City of Rockwall  
Planning and Zoning Department  
385 S. Goliad Street  
Rockwall, Texas 75087

REC CAMPUS EXPANSION  
INDOOR SHOOTING RANGE  
MIMS RD  
ROCKWALL, TX 75032  
CASE# -  
CITY SITE PLAN SUBMITTAL

**REC CAMPUS EXPANSION  
INDOOR SHOOTING RANGE  
MIMS RD  
ROCKWALL, TX 75032  
CASE #2025-12  
CITY SITE PLAN SUBMITTAL**

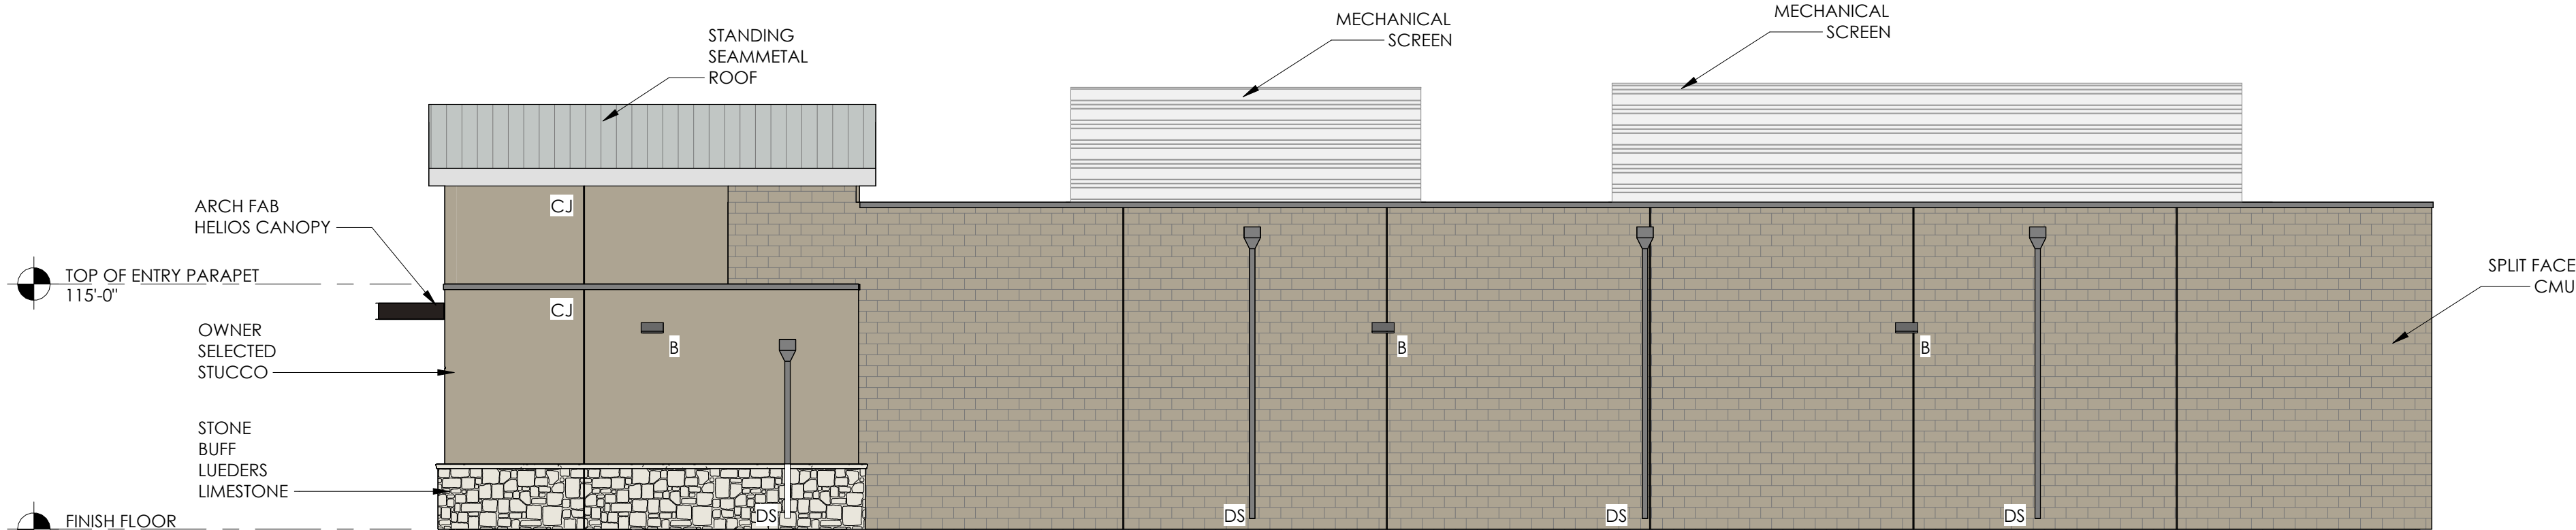
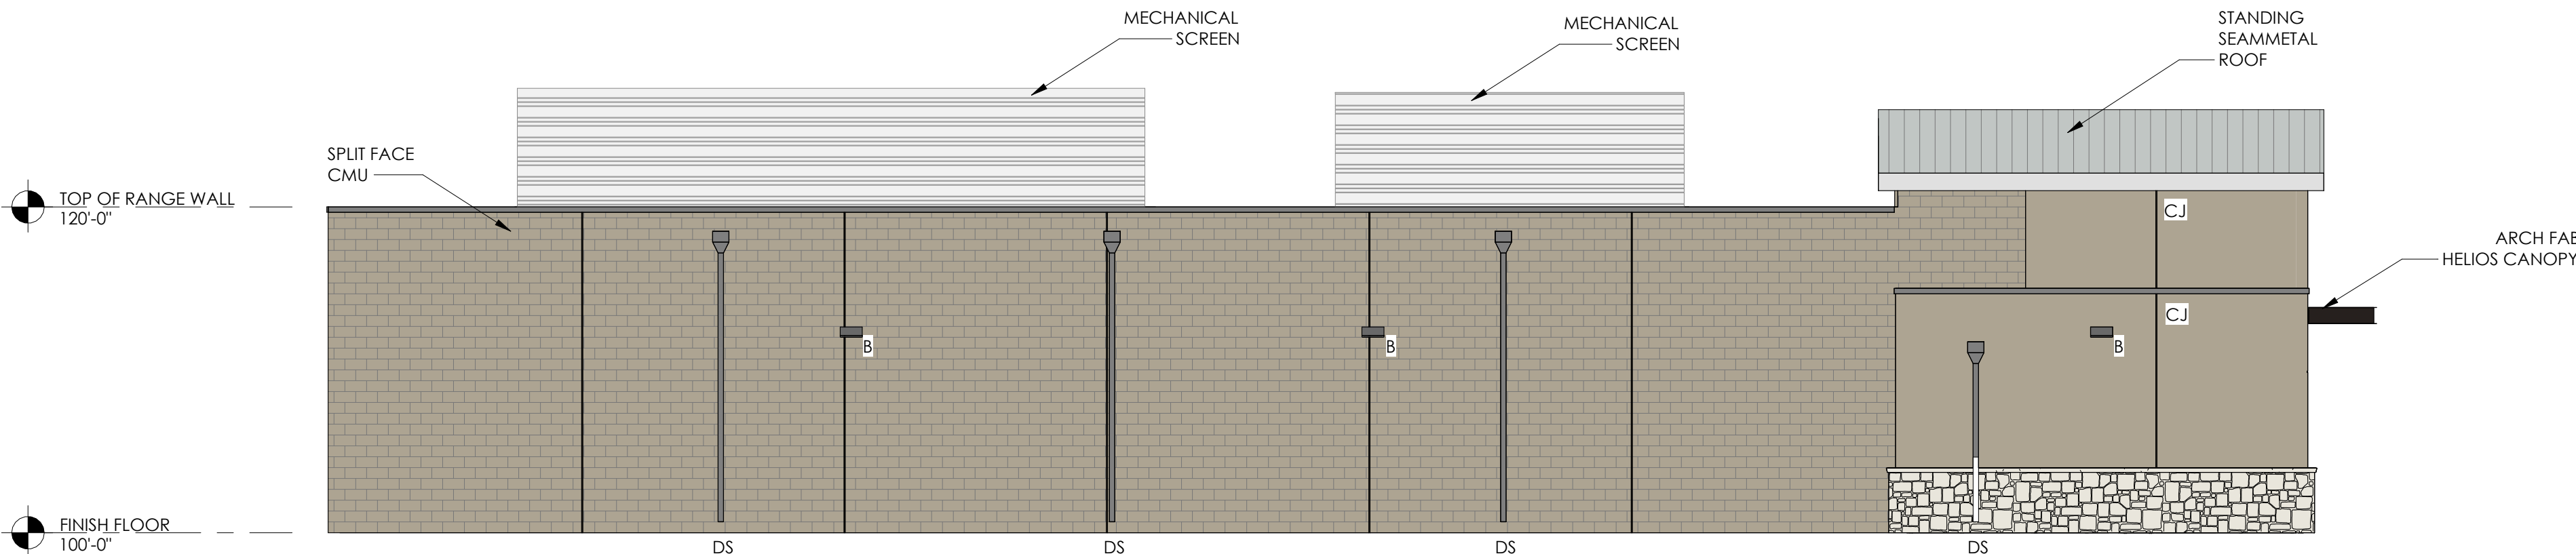
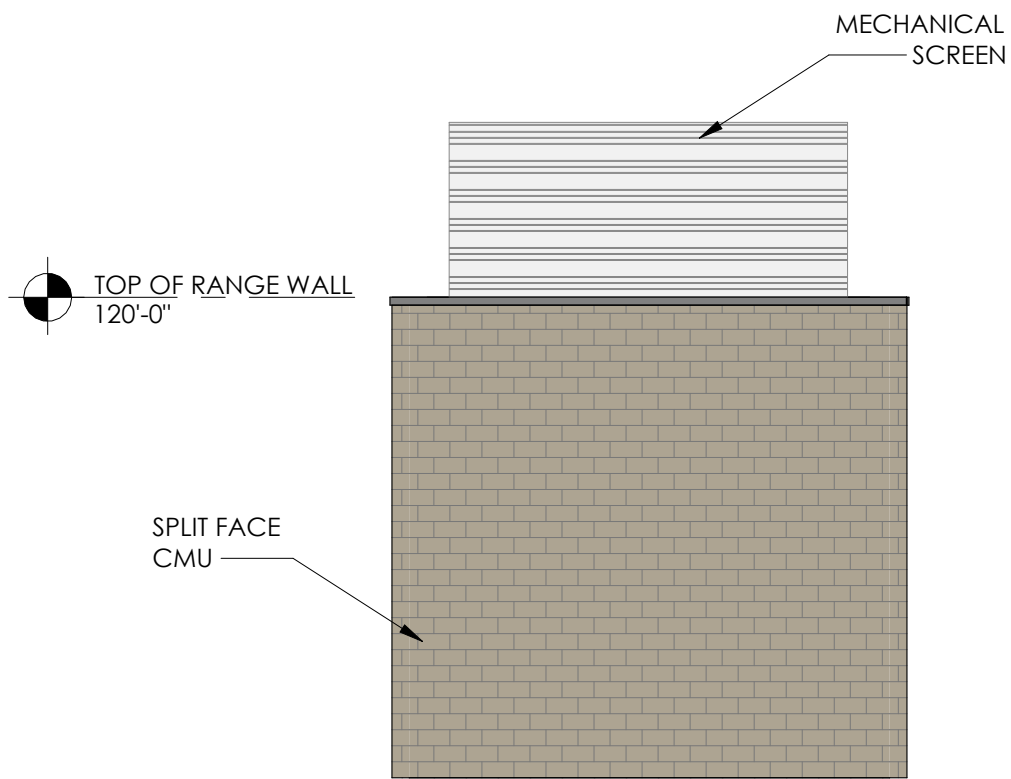
- (1) Primary and Secondary Articulation. According to Subsection 04.01(C), *Building Articulation*, of Article 05, *District Development Standards*, of the Unified Development Code (UDC), all commercial buildings shall meet the primary and secondary articulation requirements outlined in Figure 7, *Commercial Building Articulation Standards*, of Article 05, *District Development Standards*, of the Unified Development Code (UDC). In this case, each façade of the proposed building does not meet these requirements. This will require an exception from the Planning and Zoning Commission.
